## Addendum #01

Project Name: West Campus Chilled Water Loop  
Facility Name: Arkansas Tech University  
Russellville, Arkansas

Insight Project Number: 24-006  
Date: 11/22/2024

**1 POWER PLANT BUILDING - LIGHTING**  
3/16" = 1'-0"

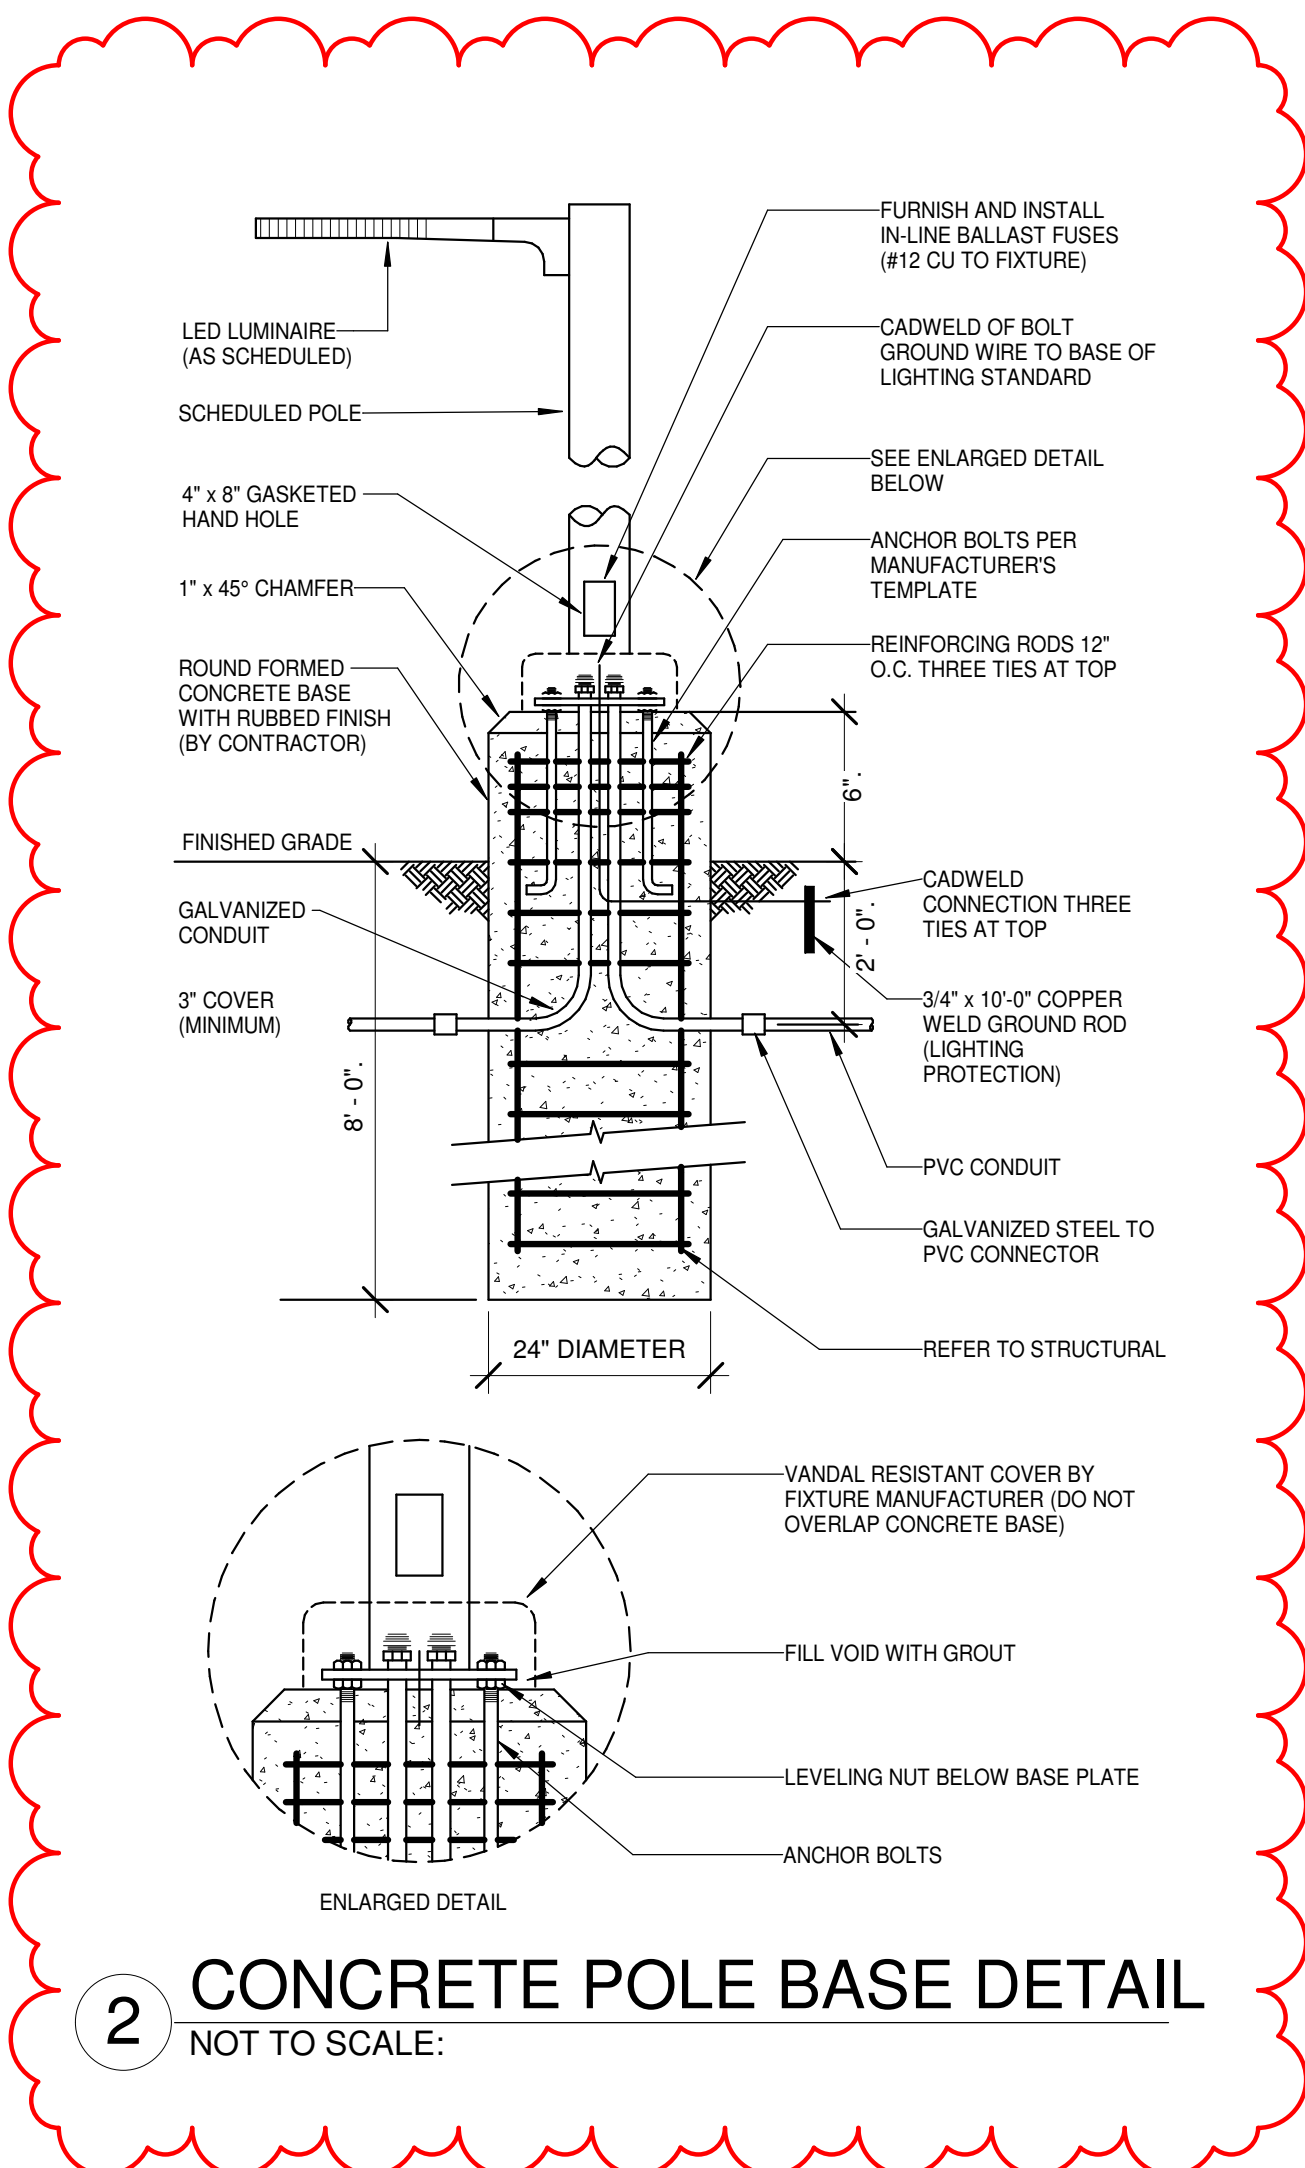
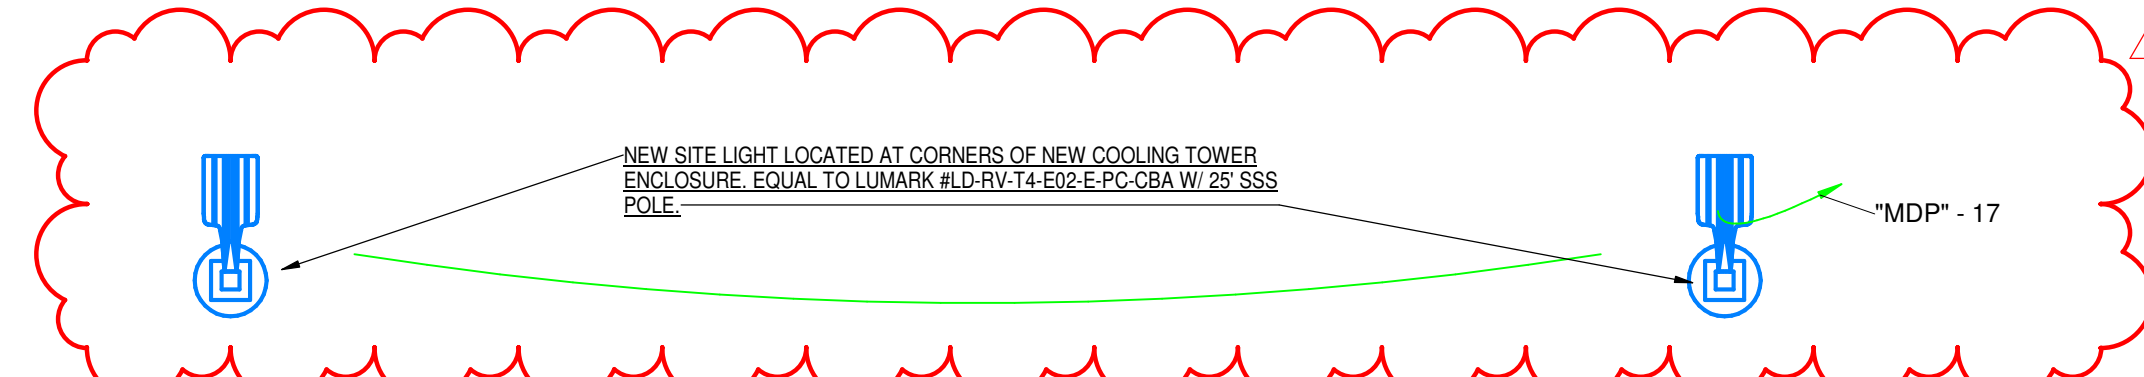
1. Refer to Sheet 201 – POWER PLANT BUILDING - LIGHTING
  - A. Added area lights and pole base detail
2. Refer to Sheet E302 – DETAILS AND SCHEDULES
  - A. Removed 2 breakers from MDP.
  - B. Added lighting circuit to MDP.

**1 POWER PLANT BUILDING - HVAC PLAN**  
3/16" = 1'-0"

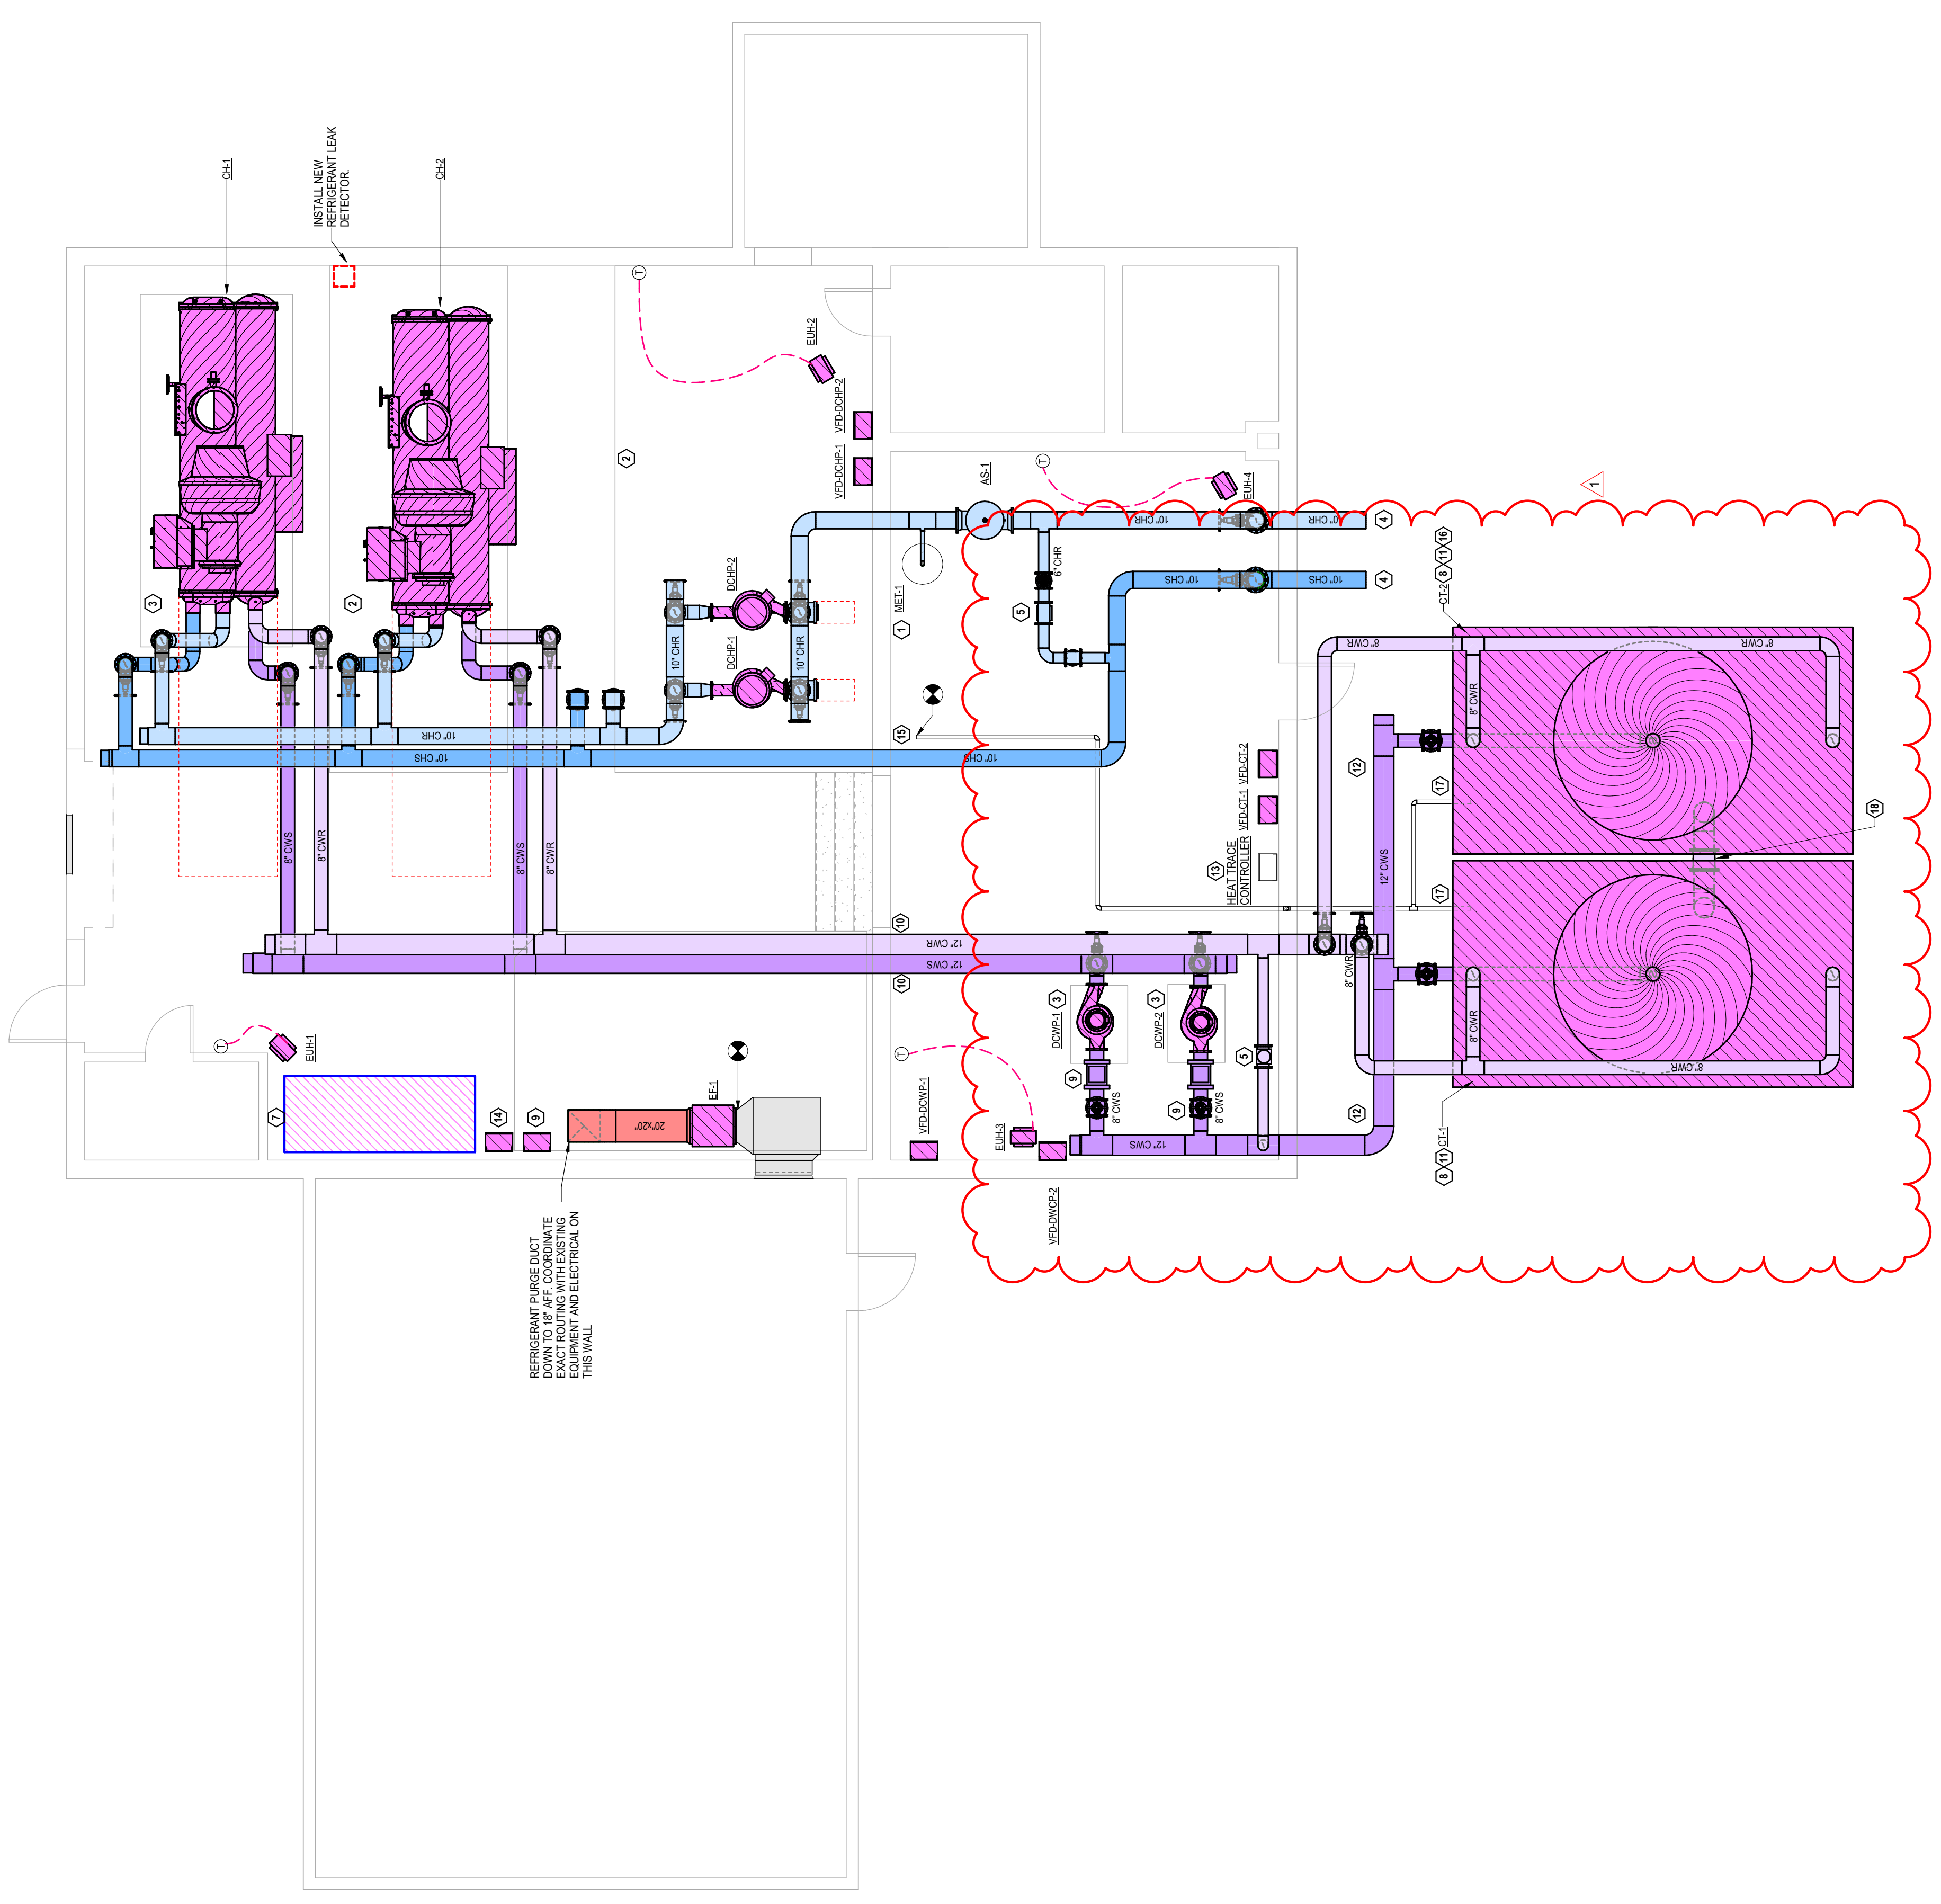
1. Refer to Sheet M201 – MECHANICAL PLAN – POWER PLANT BUILDING
  - A. Adjusted cooling tower piping.
  - B. Shifted VFD-DWCP-2 plan north.
  - C. Added keyed note 12 to the exterior piping.
  - D. Added keyed note 18 for the equalizing piping.
2. Refer to Sheet M302 – MECHANICAL DETAILS
  - A. Adjusted cooling tower piping on condenser water piping diagram detail.
3. Refer to Sheet M303 – MECHANICAL DETAILS
  - A. Adjusted cooling tower piping.

12. PROVIDE 8" WET HEAT TRACE EQUAL TO RAN/CHEM/RED CR AT 277V. INSTALL PER MANUFACTURER'S INSTRUCTIONS.
  13. PROVIDE WET HEAT TRACE EQUAL TO RAN/CHEM/RED CR AT 277V. INSTALL PER MANUFACTURER'S INSTRUCTIONS.

17. PROVIDE 2" MAKE UP WATER LINE TO BASIN OF COOLING TOWER. TO EACH BASIN. PROVIDE HEAT TRACE EQUAL TO SWIFT ON EXTERIOR MAKE-UP WATER LINE.
  18. 12" EQUALIZER PIPING WITH ISOLATION VALVE. PROVIDE 8" WET HEAT TRACE EQUAL TO RAN/CHEM/RED CR AT 277V. INSTALL PER MANUFACTURER'S INSTRUCTIONS.
